TSB G-GN-OT-0074

Date: June 2, 2025

Subject: **Non-A2L Communicating Furnace Over-The-Air Update**

Figure 1
(Continued On Next Page)

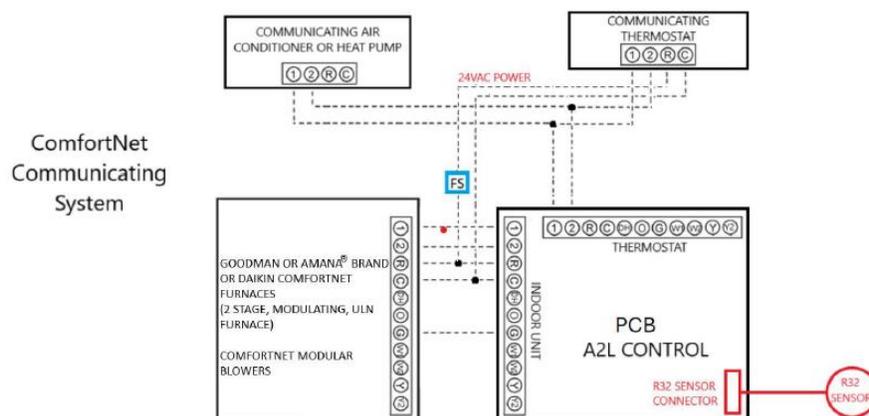
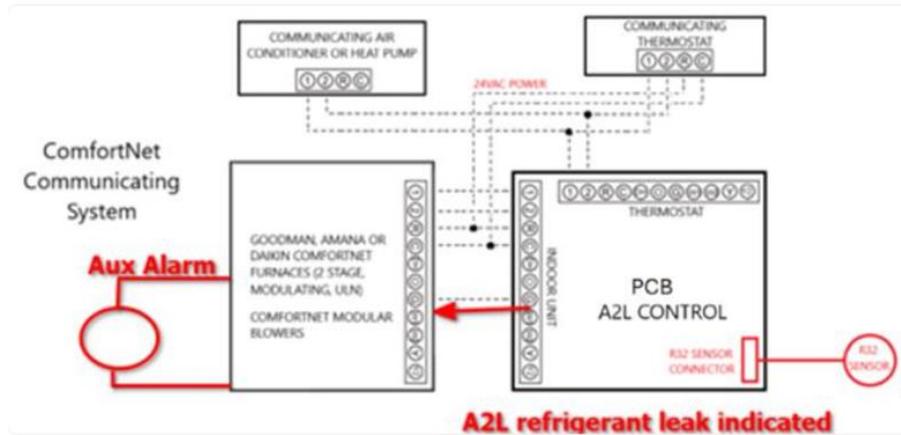
Without the Over-The-Air (OTA) update, if a condensate switch is wired through the AUX terminals on the furnace control board, an AUX alarm for a condensate switch error would not allow the blower motor to run during a refrigerant leak mitigation. The condensate switch would need to be wired between the "R" terminal on the control board and the communicating thermostat (see Figure 1).

This OTA update will also allow the blower motor to run during a refrigerant leak mitigation even when the condensate switch error is activated on the furnace board's AUX terminals. With the OTA update the float switch can be wired through the AUX terminals on the furnace control board (see Figure 2). If an AUX Alarm for a condensate switch error occurs along with a refrigerant leak mitigation, a "G" call from the Furnace Integration Kit will enable the blower motor to run at the constant fan airflow setting.
